Written Representation
for the
Royal Society for the Protection of Birds
Annex A
Comments on the Applicant's Bycatch reduction documents
submitted at Deadlines 1 and 2

Submitted for Deadline 4
10 May 2022

Application by Hornsea Project Four Limited for an Order
Granting Development Consent for the Hornsea Project Four Offshore Wind
Farm

Planning Inspectorate Ref: EN010098
RSPB Registration Identification Ref: 20029909

Figure 1 Pelagic longline compared to demersal longline fishery.⁴

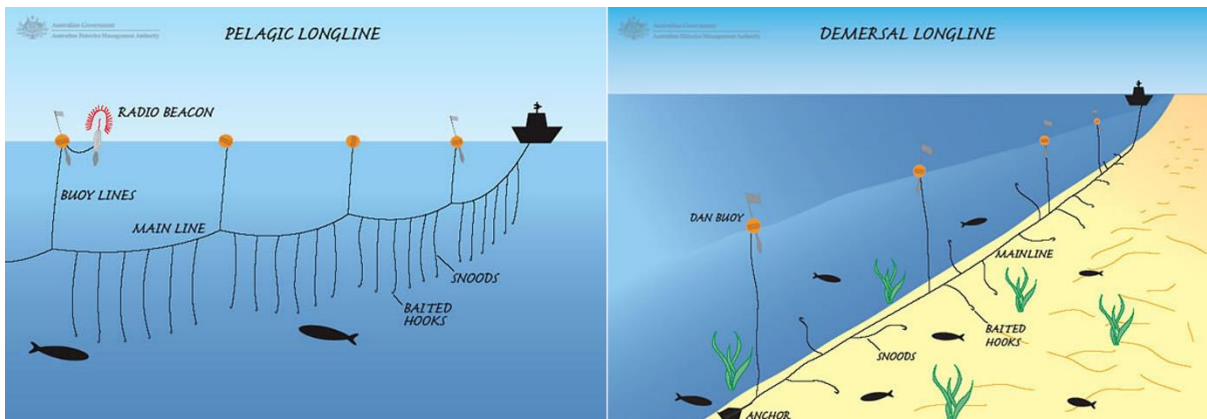
- 2.11. The Applicant presents an illustration of a pelagic longline fishery (Figure 1, section 4.3.3.2, page 15) but does not clearly state whether pelagic and/or demersal fisheries will be targeted. Figure 1 below shows the difference between demersal and pelagic longline fisheries. The distinction between pelagic and demersal fisheries is important as they require different gear types. As a result ACAP provide different best practice advice for bycatch reduction in demersal and pelagic fisheries.

- 2.12. It would therefore be helpful if the Applicant could set out which fishery types they are targeting and, for each fishery type, which mitigation options they are considering and why. This would enable Interested Parties to assess the suitability or otherwise of the proposed mitigation options.
- 2.13. The Applicant refers to “Lumo leads (line weighting)” (page 10, section 1.2.1.5). We note that Lumo leads are only one type of line weighting measure, designed for branch line in pelagic fisheries rather than demersal gear which is constructed differently. Other types of line weighting exist that are suitable for demersal fisheries.
